(UNCLASSIFIED)
 REPORT OF FRAGILITY TEST
 ON
 SMB-1-25/H4BC
 WITH STANDARD CAST ADAPTER
 FOR
 LIMITORQUE CORPORATION
 KING OF PRUSSIA, PENNSYLVANIA

D
Shearon Harris Nuclear Power Plant
Draft SER Open Item No. 354
NRC Question 210.52

Shearon Harris Nuclear Power Plant
Draft SER Open Item No. 354
NRC Question 210.53

210.55

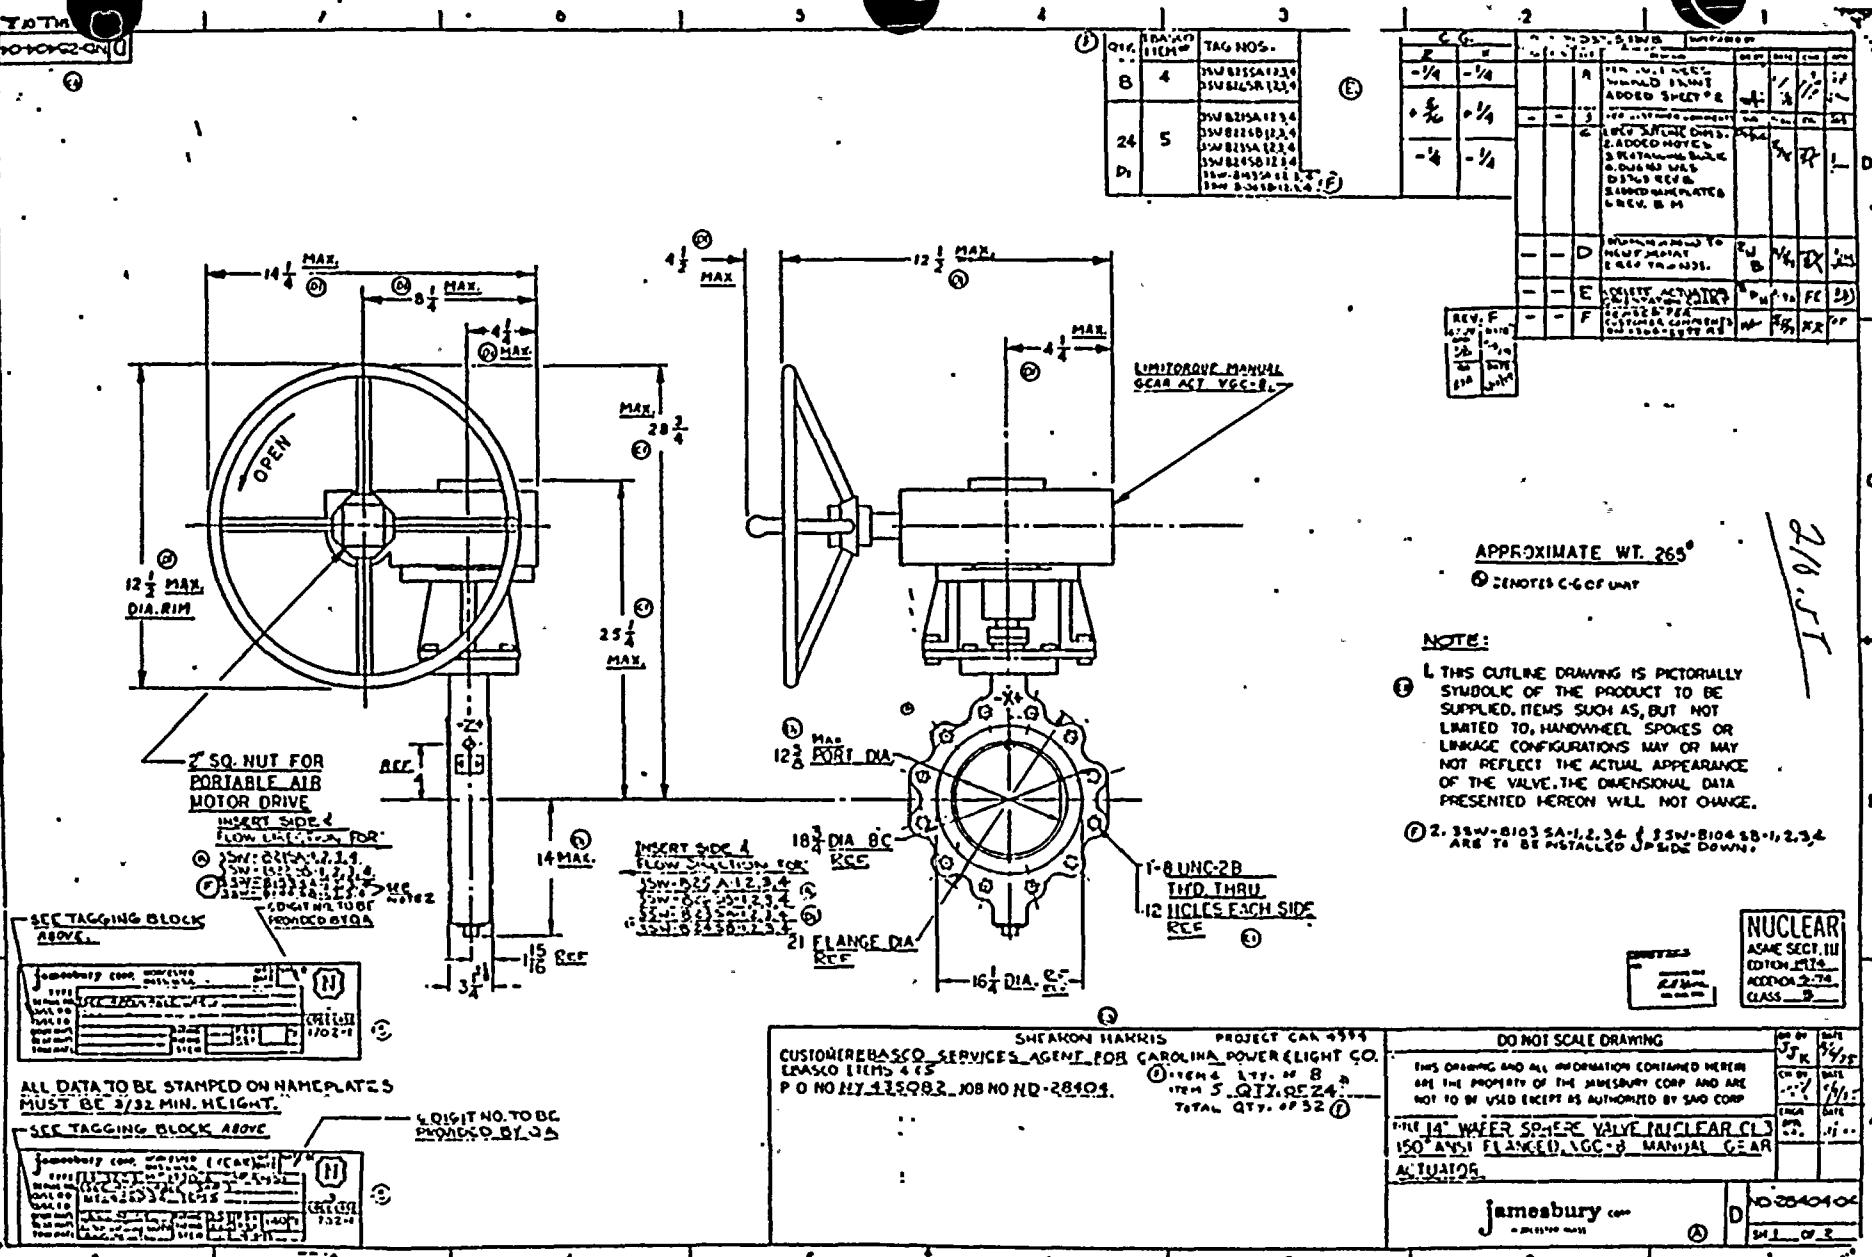
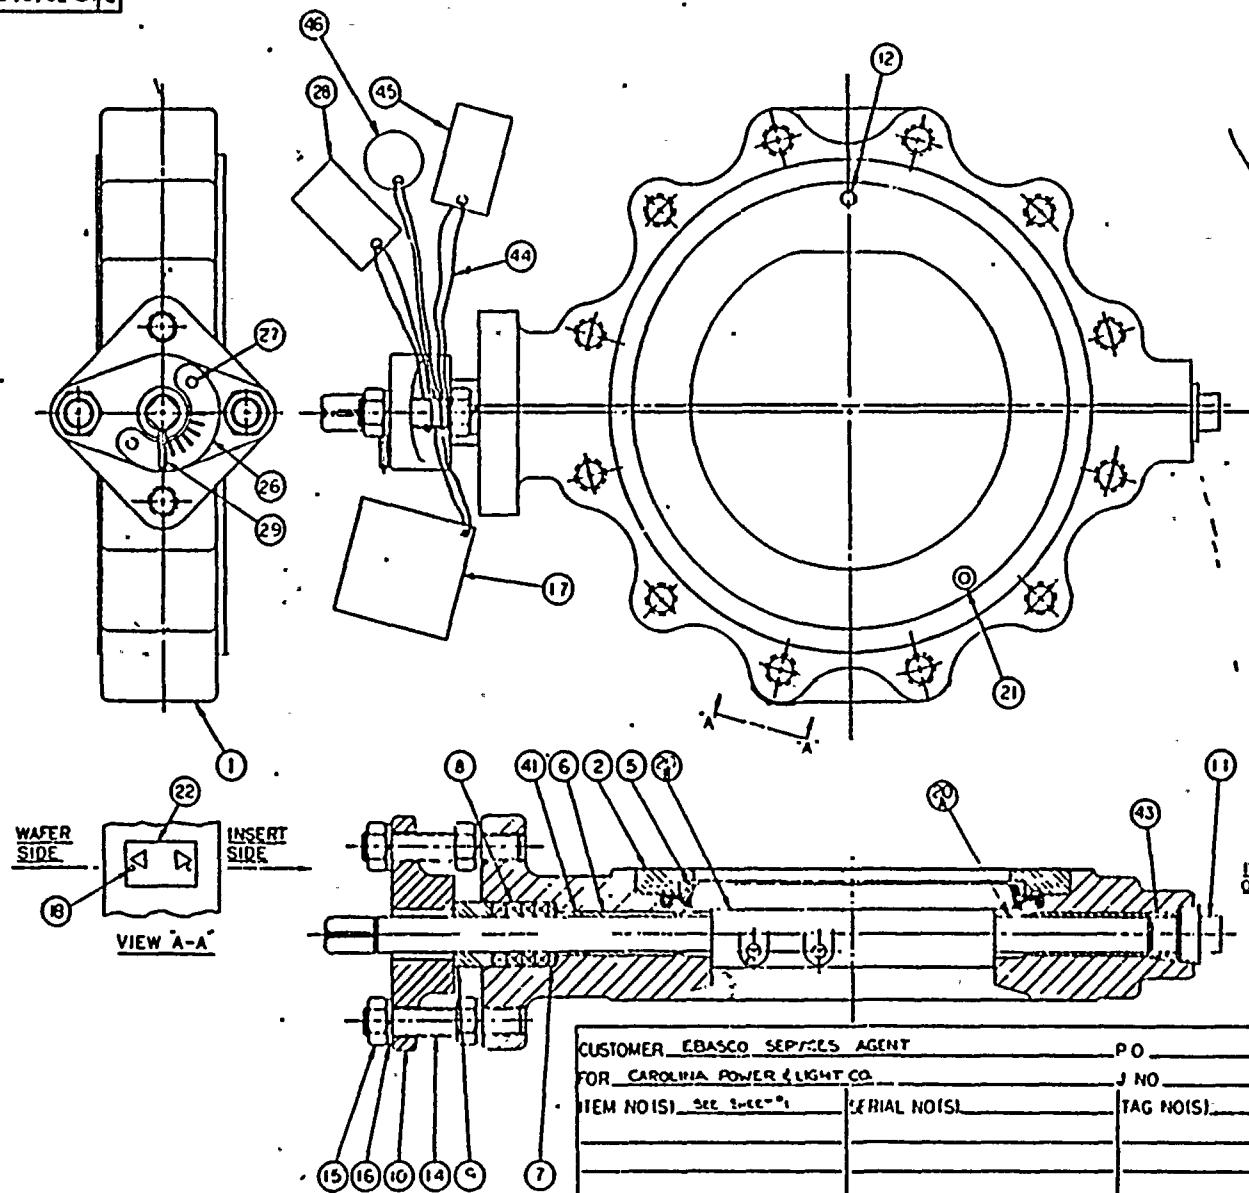
The procedure in Report JHA-77-99 dated 8/2/78 is incomprehensible without drawings of the valves. Furnish drawings for the valve identification on Butterfly Valve Data Sheet 5 of 48, P. O. No. NY-435082. The drawings should be in sufficient detail so that we can check the dimensions used in the calculations in the Report for this specific valve.

Please find attached copies of valve drawings on Valve Data Sheet 5 of 48. These are the drawings furnished by Jamesbury to Ebasco. Jamesbury do not release detail (shop) drawings of their product other than to an independent engineering consultant for analysis work. However, if a specific dimension or group can be identified for a given part we can more easily comply with your request.

210.57

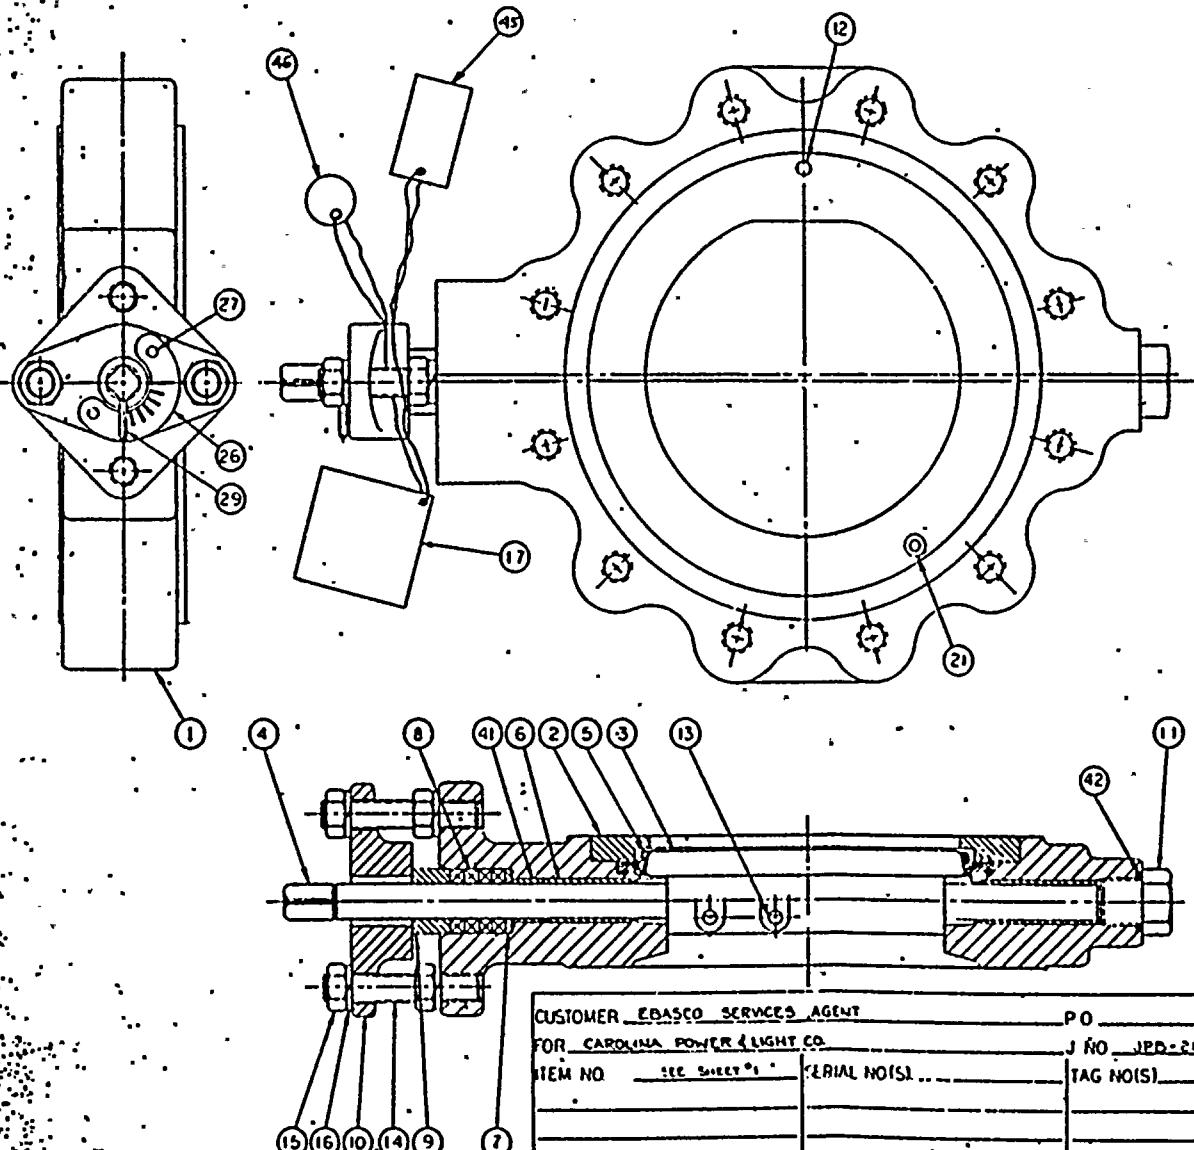
- (a) Where did the 95000 (psi?) yield strength for "Type 316 ST. STL." come from?
- (b) Material to A-564 Type 630 is furnished with minimum specified yield strengths ranging from 75 ksi to 170 ksi, depending upon the hardening and/or aging treatment. Where does the Specification CAR-SH-M-44, Rev. 13 address this treatment so that the Report can use a yield strength of 125 ksi?

- (c) Page 93 of the Report shows calculated shaft membrane plus bending stresses of up to 74000 psi. If failure of the shaft can lead to failure of the pressure boundary and if the calculated stresses are mainly due to pressure, the calculated stresses are deemed to be excessive. What are the calculated shaft stresses for the valve identified in Butterfly Valve Data Sheet 5 of 48, P. O. No. NY-435082 due to the Design Pressure of 225 psig? What are the allowable stresses for design conditions and where are they identified in the Specification?

- (a) The 316SS referenced is per 00-S-763 condition B which has a yield of 95000 psi. The shaft material was later changed to ASTM A-564 type 630 H1025. (See approved outline/assembly drawing). The yield is higher for A-564 than 00-S-763.

- (b) The Specification does not specify detail requirements of all materials used to fabricate the valves. The Seller had selected A-564 Type 630 H1025 as the shaft material as indicated in the valve assembly drawings (sample attached). Therefore, the use of 125 ksi yield strength is appropriate, per ASME material specification (A-564 type 630 H1025-Yield stress = 145,000 psi).

- (c) The 14" valve with SMB-000/2HIBC Actuator was deleted from the contract and is not applicable. However, the stress shown is for a design pressure of 225 psig and qualifies shaft for the item on data sheet 5 of 48 with gear actuator. The valve shaft is not a pressure retaining part by ASME Section III Code and the actual allowable stress is per the AISC manual of steel construction or $0.9 \times S_y$ of $145000 = 130500$ psi, hence a 76% safety factor on allowable.
